Town of Groveland
Economic Development
Planning & Conservation Department
Planning Board
183 Main Street
Groveland, MA 01834

Board/Committee Name: **PLANNING BOARD**
Date: **TUESDAY, November 19, 2024**
Time of Meeting: **7:00 PM**
Location: **Town Hall 183 Main Street
Groveland, MA 01834**
Signature: *Annie Schindler*

CONTINUED 181R SCHOOL STREET:

A hearing in accordance with M.G.L. Chapter 41, Section 81T, the Town of Groveland Subdivision Rules and Regulations and Article 14 of the Groveland General Bylaws, to hear the application of Groveland Redevelopment LLC. c/o Louis Minicucci Jr, 231 Sutton St, Suite 1B, North Andover MA 01845, requesting approval of a six (6) lot Definitive Subdivision Plan labeled 181R School Street, Groveland, Massachusetts and associated Stormwater Management & Land Disturbance Permit. The site is located in the Residential 2 (R-2) Zoning District. The proposed subdivision is located at 181R School Street Groveland, MA 01834. (Assessors Map 34, Parcel 13).

**SHEET TITLE:
BENJAMIN STREET EXT.
ROADWAY
AS-BUILT SITE PLAN**

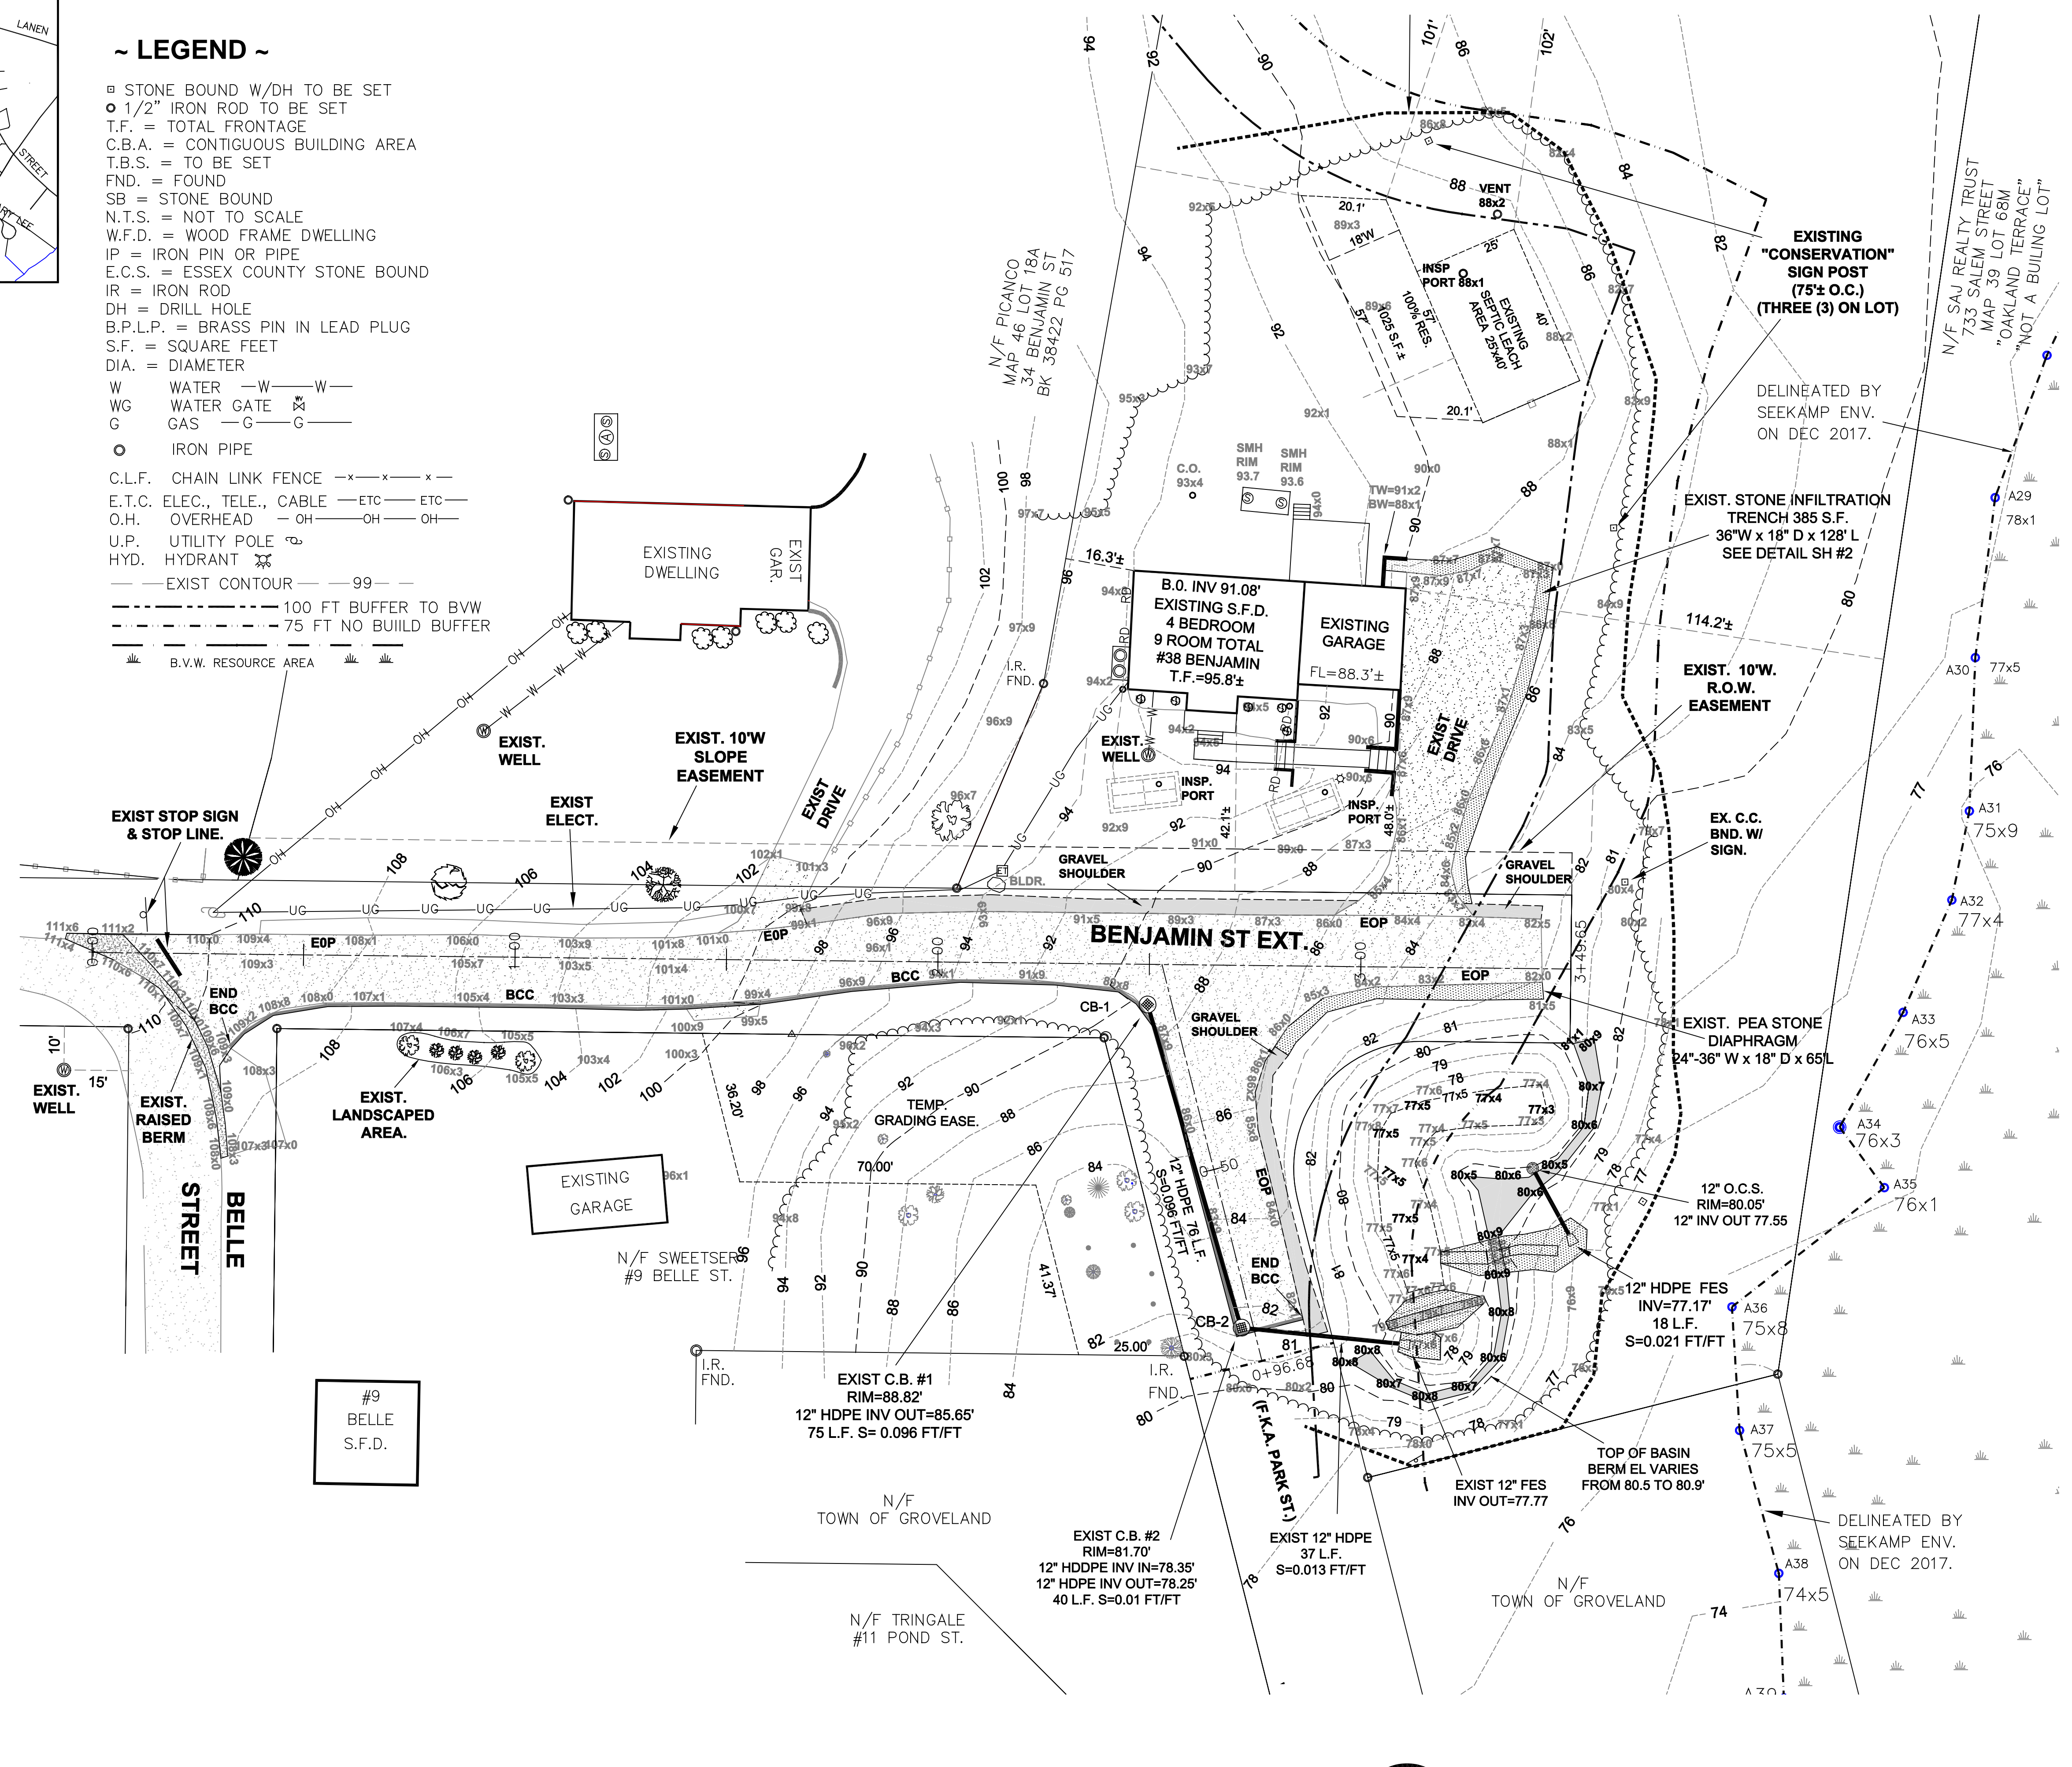
- The existing ~24" tree used as construction TBM is surveyed on the northern side of the 34/38 Benjamin Street property line on the As-Built Plan. In the most recent Landscaping Plan dated 05/28/2020, the existing ~24" tree was surveyed on the southern side of the 34/38 Benjamin Street property line. The contractor should confirm the locations of the property line and this landmark.
- The electrical connection to 38 Benjamin Street was observed to be underground.
- Near the connection to Belle Street, the two northernmost symbols denoting trees were not observed on site.
- The surveyed property lines do not display bearing and distance.
- The property owner of 38 Benjamin Street is not displayed on the plan.

REVISIONS			SITE LAYOUT	DRAWING NO. C-5
NO.	DESCRIPTION	DATE		
1	PER PEER REVIEW	11/5/24

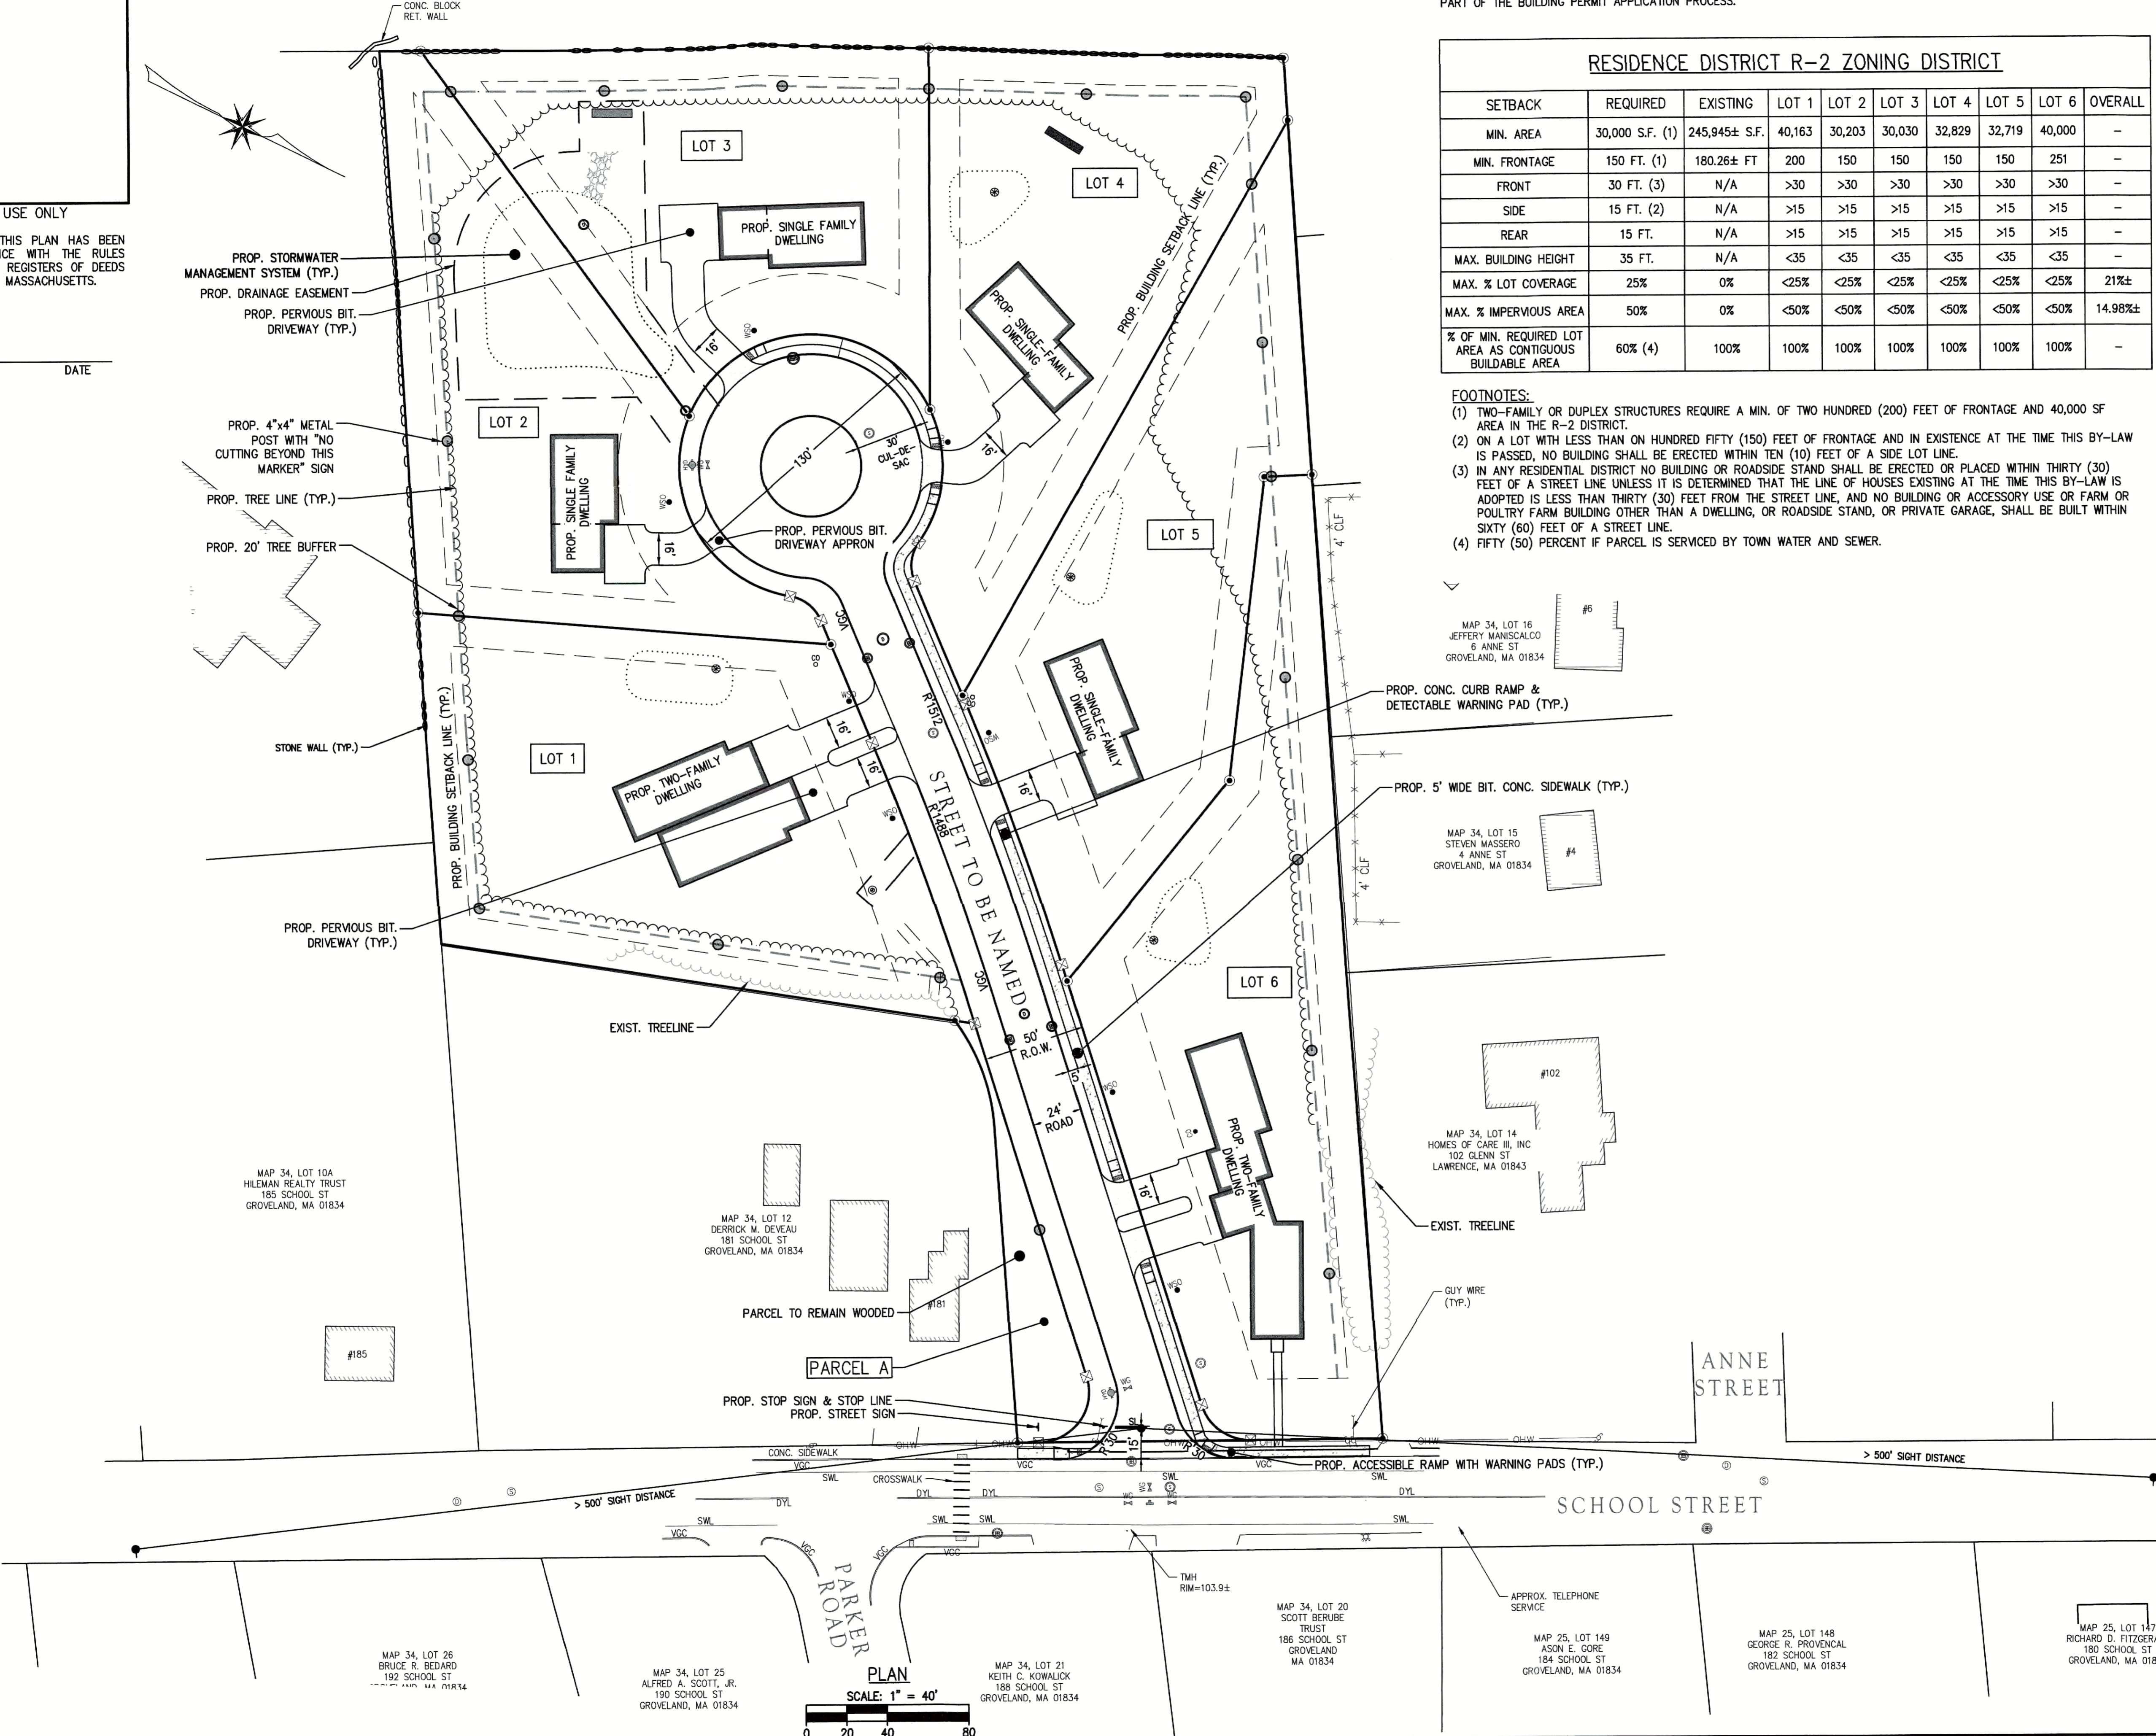
13. **TEC Comment:** *14.10.C.16 – The proposed drainage area of leading to DP-1 does not appear accurate given the proposed grading and roadway layout seen on sheets C-6 and C-7. The applicant should revise their plans and associated calculations accordingly.*
MCG Response: Additional spot grades were added to clarify the grading intent.

- c. *On Sheet C-6, The bottom contour (elevation 97) appears to be missing from rain garden P5.*

21. **TEC Comment:** *For rain garden P6 shown on sheet C-6 of the site plans, the top of garden elevation is lower than the bottom of garden elevation. The applicant should revise this label accordingly.*
MCG Response: The label has been updated to clarify that.

13. **14.10.C.16** – The proposed drainage area of leading to DP-1 does not appear accurate given the proposed grading and roadway layout seen on sheets C-6 and C-7. The applicant should revise their plans and associated calculations accordingly.

- c. On Sheet C-6, The bottom contour (elevation 97) appears to be missing from rain garden P5.
- d. On Sheet C-7, there is no label detailing the proposed rim or invert elevation(s) for proposed catch basin 2 (CB-2).

21. For rain garden P6 shown on sheet C-6 of the site plans, the top of garden elevation is lower than the bottom of garden elevation. The applicant should revise this label accordingly.
